4. CASE 22. 092, 171 CONGDON STREET, Ephraim Martin House, 1856 (COLLEGE HILL)

Project: Three Family Residence
Address: 171 Congdon Street, Providence, RI 02906
Date: 7 July 2022
Re: Application Information

NARRATIVE – Scope of Work

1 FIRST FLOOR PLAN
A1.1 1/8" = 1'-0"

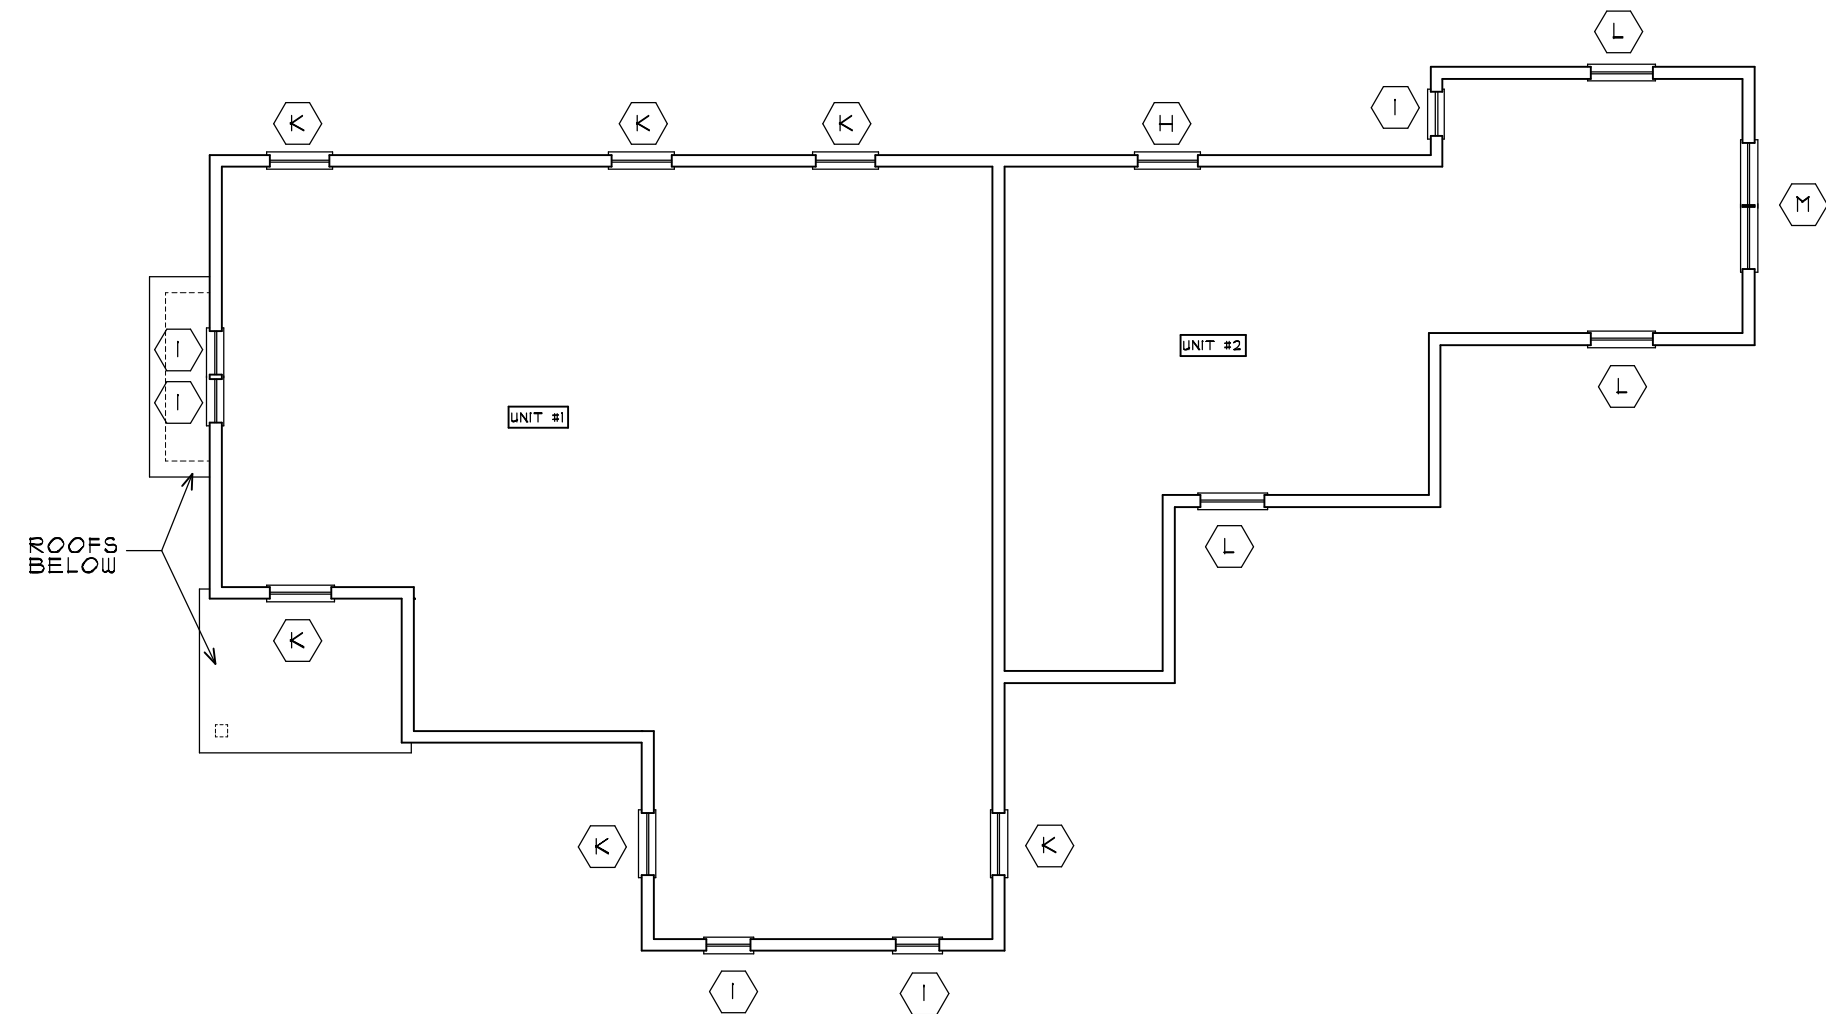
- Windows: The applicant would like to replace window sashes on the first and second floor with new, insulated units. Windows in the street bay (5) and tower (6) shall remain untouched; The owner started to replace windows on the first and second floor prior to HDC approval, identified as "M" units. This includes nine (9) units on the first floor and eight (8) units on the second floor. In addition to units in place, the owner is requesting to replace four (4) units on the first floor, eight (8) units on the second floor and three (3) in the attic; The new windows shall be Pella Impervia fiberglass double hung units. Muntins to be simulated divided light. Exterior color to be white. The existing sashes and aluminum storm windows shall be removed;

1 WEST ELEVATION - CONGDON STREET
A2.1 1/4" = 1'-0"

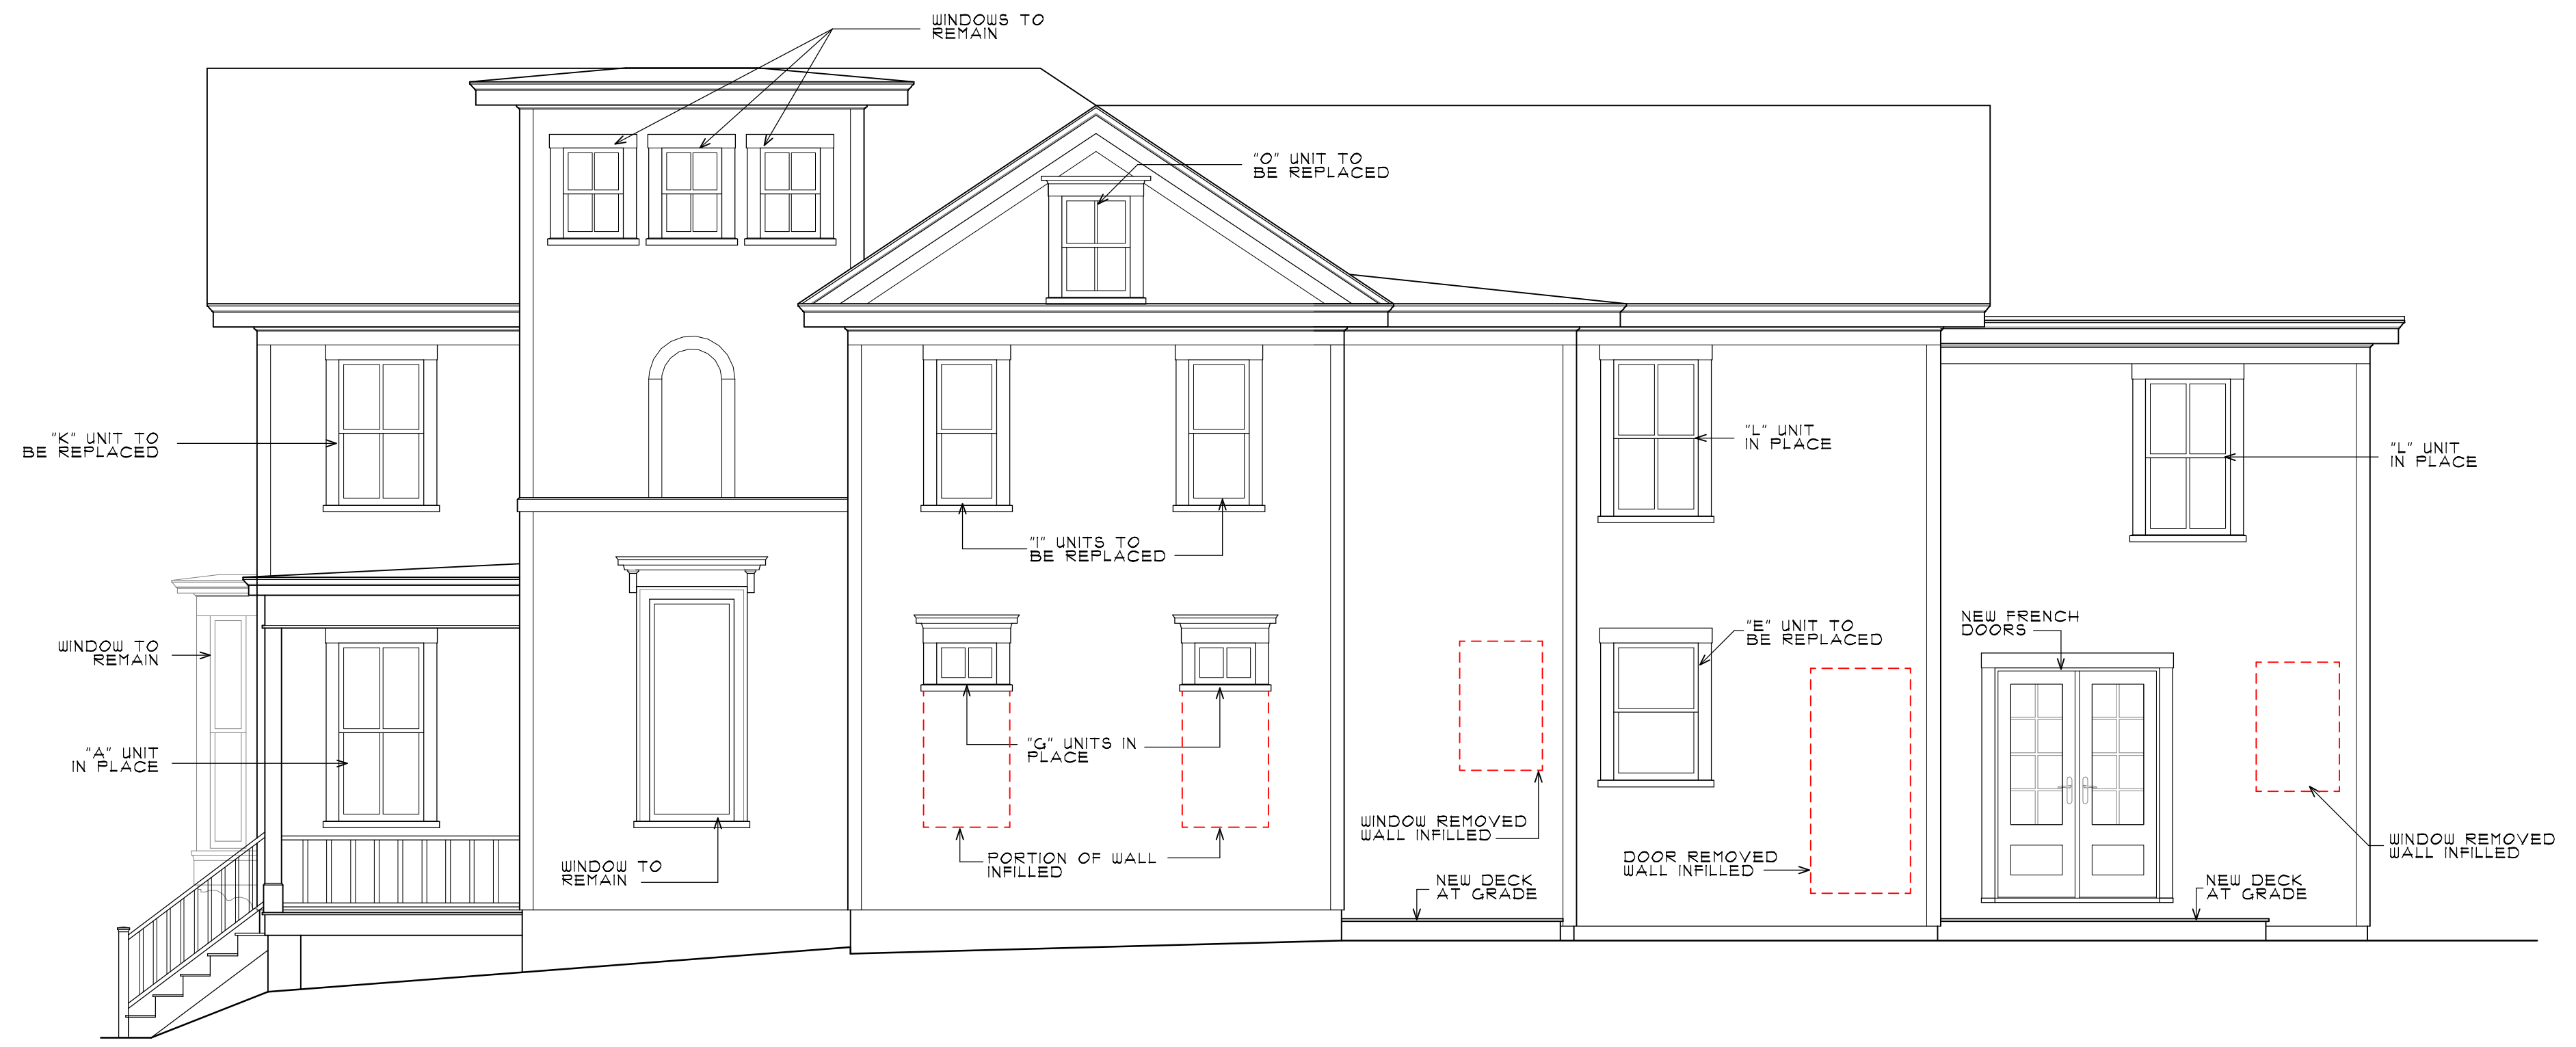
- New Entry Porch and Decks: North Elevation – New entry porch 4' x 5' shall be 1x6 Trex on P.T. framing. Rails to be painted wood as shown. Southeast Area – Two new grade level decks are to be built to provide access to new patio doors. Each deck to be 1x6 Trex on P.T. framing of the size shown on the drawings;

4 NORTH ELEVATION
A2.1 1/4" = 1'-0"

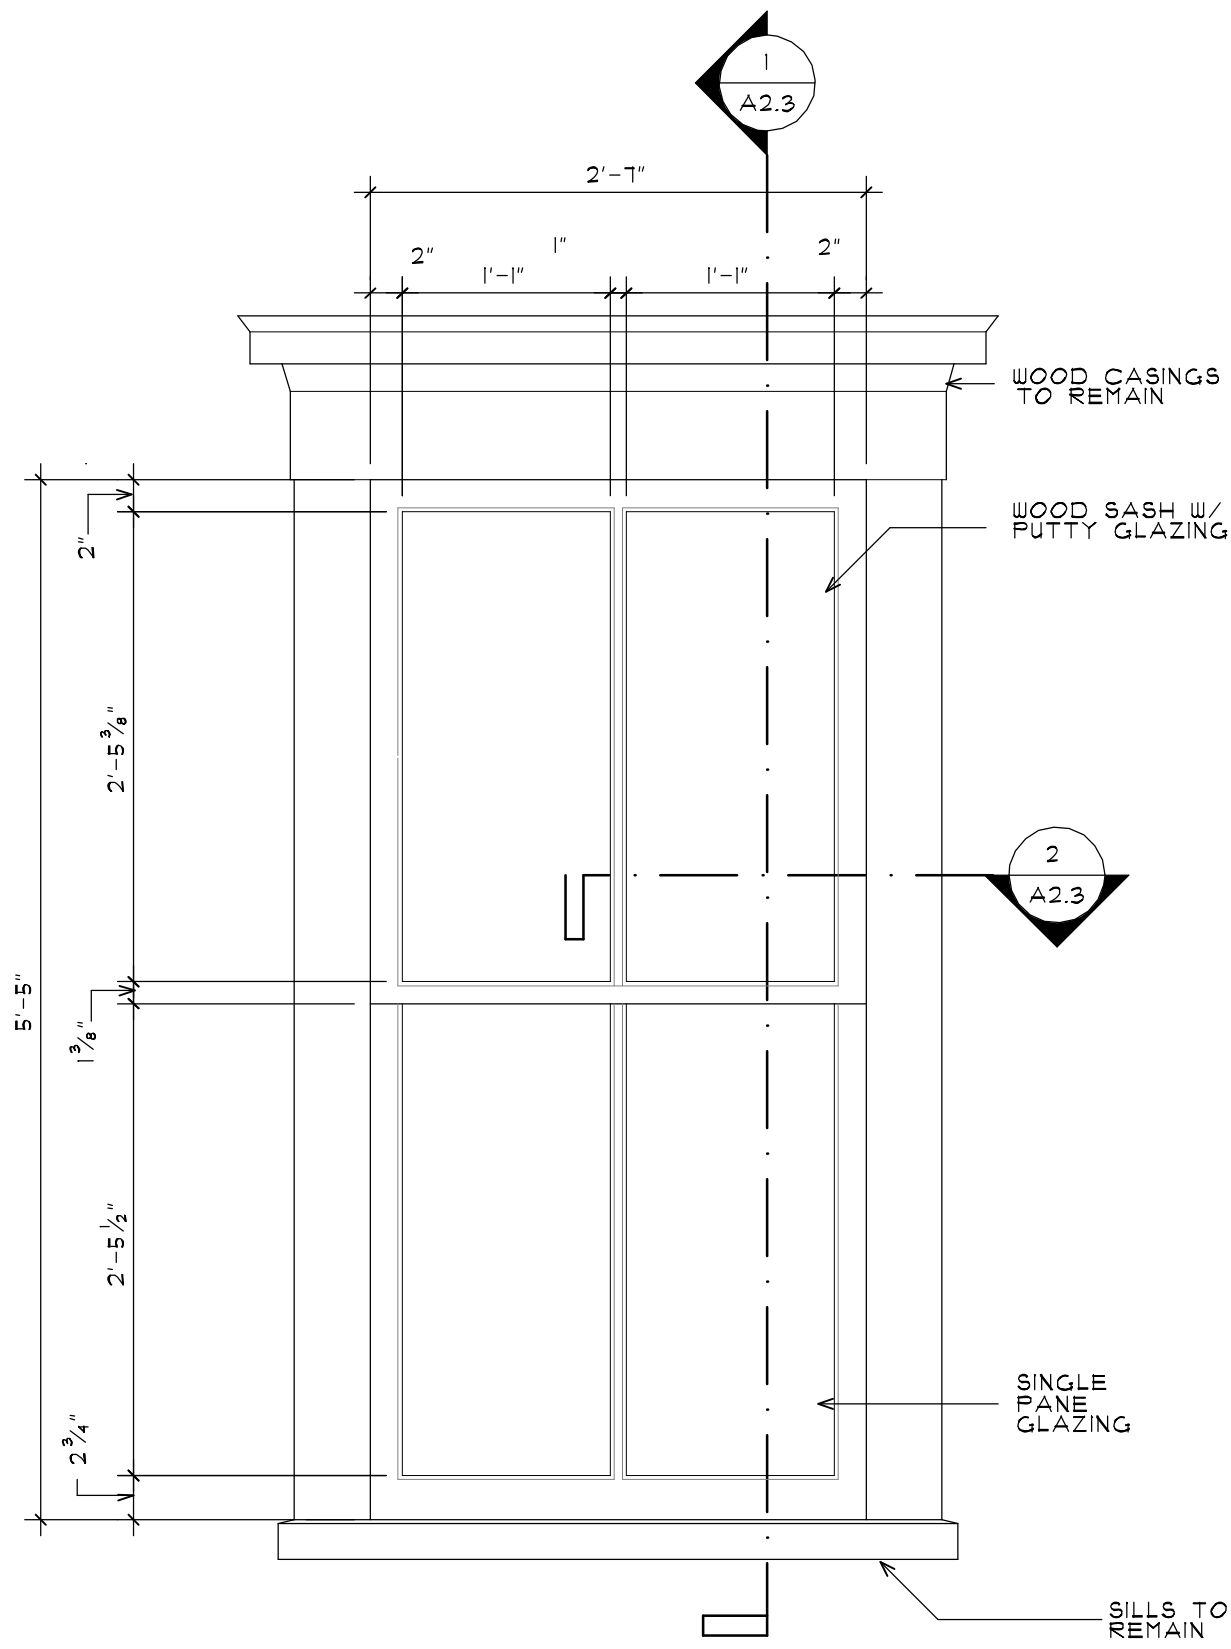
- New Exterior Doors: North Elevation – New 6 panel fiberglass door. w/ two lights, has been installed to provide entry access to rear unit. Painted wood casings to match house casings. Southeast Area – New Marvin patio doors (2) have been installed to provide access from each unit to rear yard. Doors are ¾ lights w/ flat panels, Marvin Ultimate swinging door, aluminum clad wood door. Painted wood casings to match house casings

2 PROPOSED SASH REPLACEMENT
1" = 1'-0"

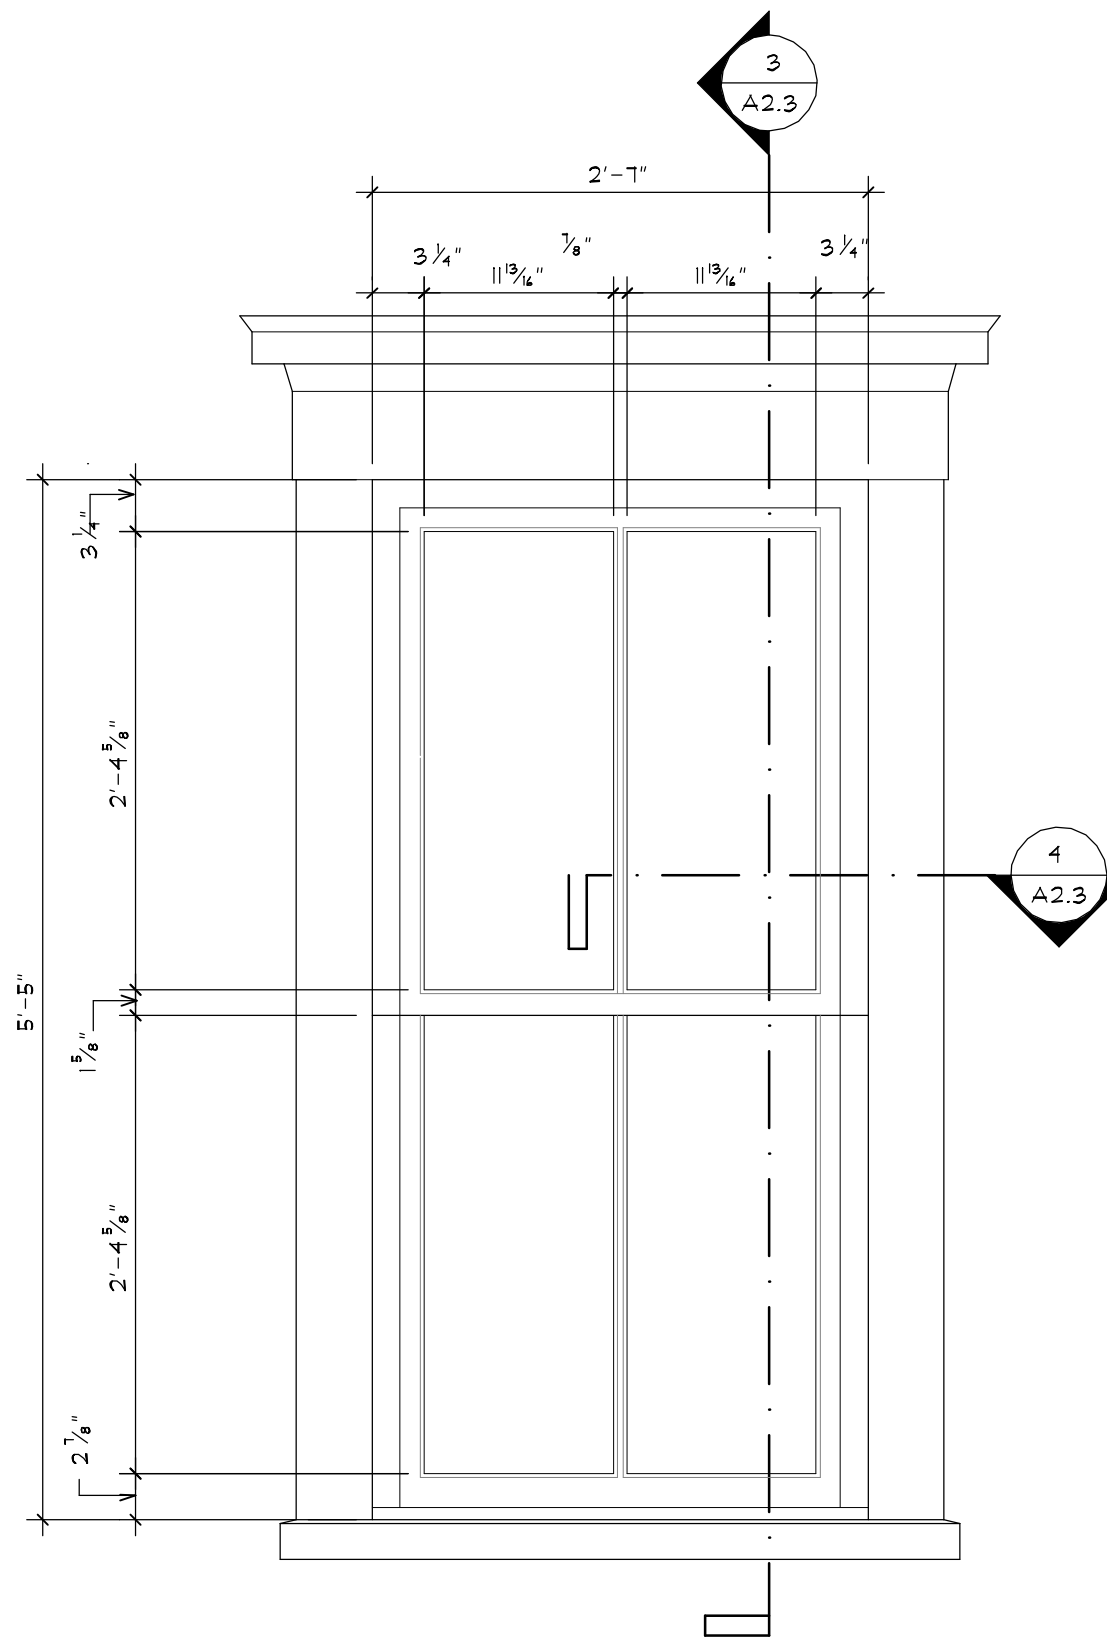
The client would like to replace window sashes on the first and second floor with new, insulated units. Windows in the street bay (5) and tower (6) shall remain untouched.

The new windows shall be Pella Impervia fiberglass double hung units. Muntins to be simulated divided light. Exterior color to be white.
